2021 EXTERIOR FACADE
REPAIR PROJECT: PHASE I
CITYVIEW CO-OP
MINNEAPOLIS, MN

SHEET TITLE:
**STRUCTURAL
REPAIR
DETAILS**

STRUCTURAL ADDENDUM
05/12/2021

STRUCTURAL NOTES:

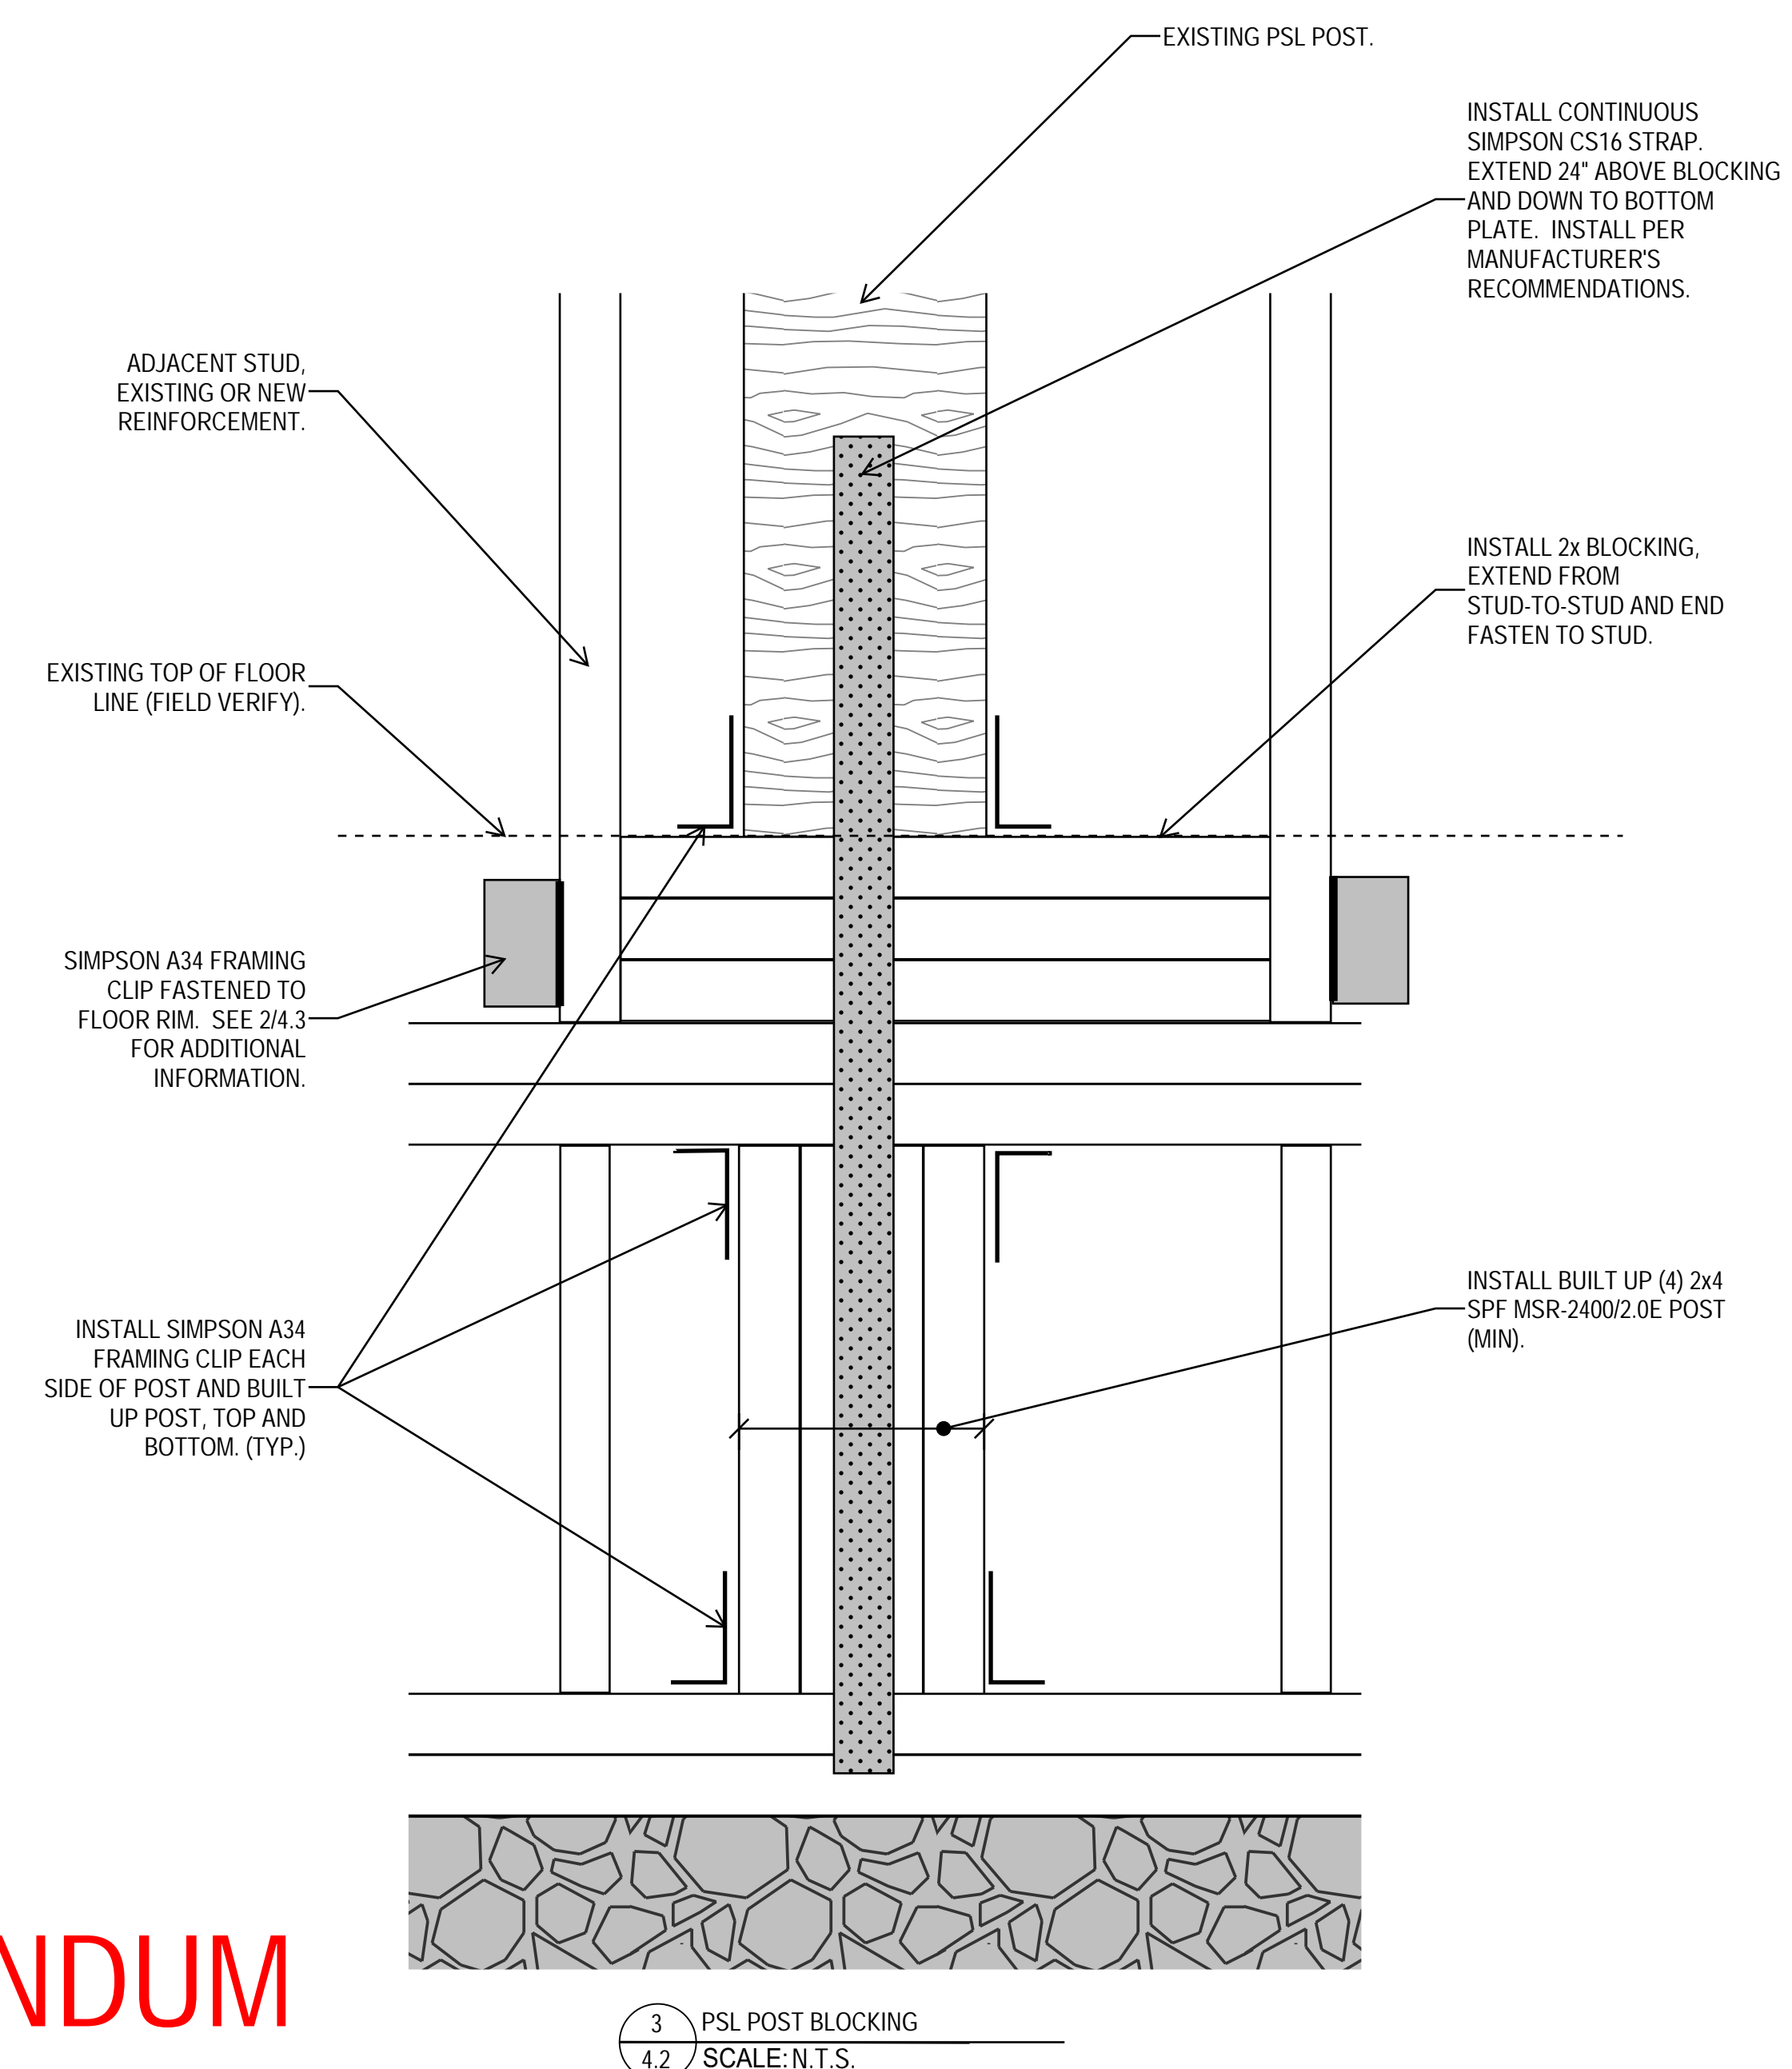
3. REPAIR TO CONSIST OF CUTTING AND REMOVING PORTIONS OF WATER DAMAGED STUD FRAMING AND REINFORCING EXISTING STUDS WITH 2x4 SPF MSR-2400/2.0E FULL HEIGHT STUDS. AT LOCATIONS WHERE FRAMING IS LESS THAN 6'-0" IN LENGTH, CONTRACTOR MAY SUBSTITUTE REINFORCEMENT WITH FULL HEIGHT 2x4 SPF #2 OR BETTER. REINFORCEMENT TO BE SISTERED TO SIDE OF EXISTING STUDS PER NDS RECOMMENDATIONS.

4. CONTRACTOR TO CUT EXISTING BALLOON FRAMING STUDS AT FLOOR LINES AND INSTALL A CONTINUOUS DOUBLE PLATE ALONG EACH FLOOR LINE.
5. CONTRACTOR TO ATTACH WALL FRAMING TO FLOOR DIAPHRAGM AT OR BELOW EXISTING FLOOR LINE WITH FRAMING CLIPS.

6. CONTRACTOR TO INSTALL STRAP AND HOLD DOWNS FOR LATERAL WIND LOAD DISTRIBUTION PER 1/4.2. STRAP AND HOLD DOWN LOCATIONS TO BE ALIGNED. CONTRACTOR TO INSTALL ADDITIONAL REINFORCEMENT FRAMING AND BLOCKING AS REQUIRED TO ALIGN STRAPS AND HOLD DOWNS.

7. ALL EXTERIOR SHEATHING ON THE EAST ELEVATION TO BE REPLACED WITH 7/16" APA RATED EXTERIOR SHEATHING, ORIENTED VERTICALLY WITH HORIZONTAL JOINTS BLOCKED. PLYWOOD WALL PANELS SHALL BE ORIENTED WITH FACE GRAIN PARALLEL TO SUPPORT STUD.

4.3

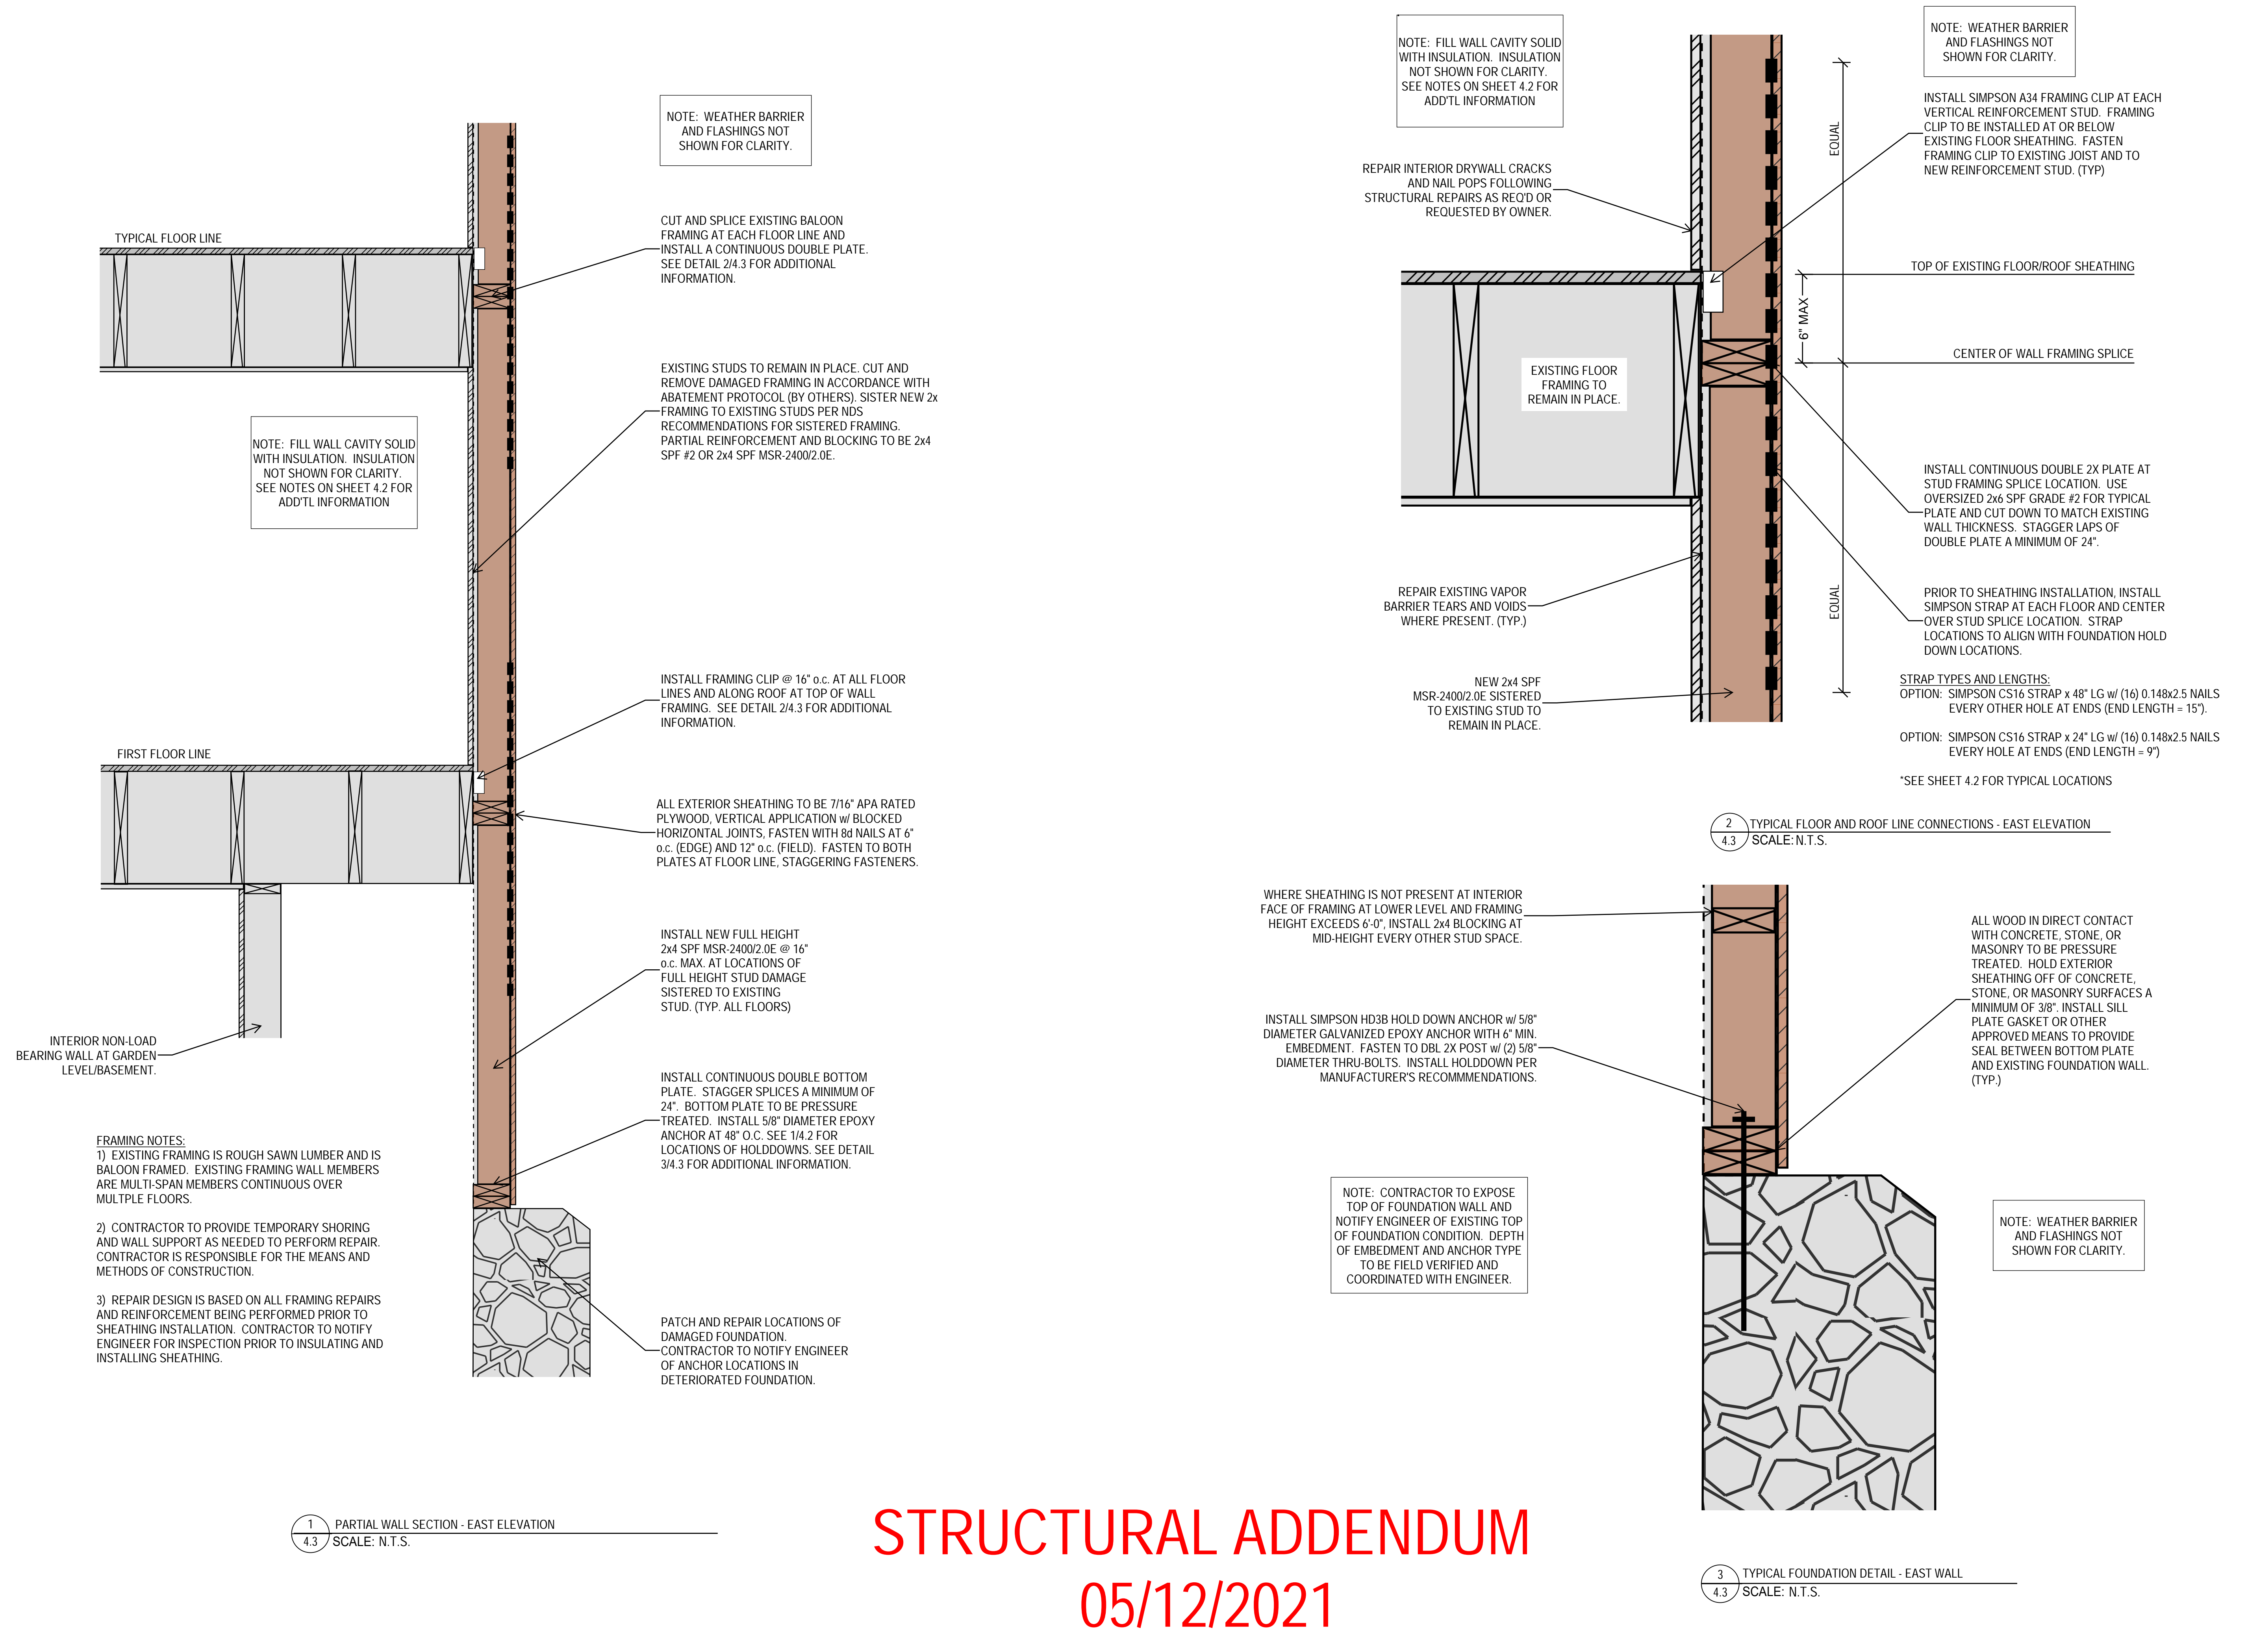
STRUCTURAL ADDENDUM
05/12/2021
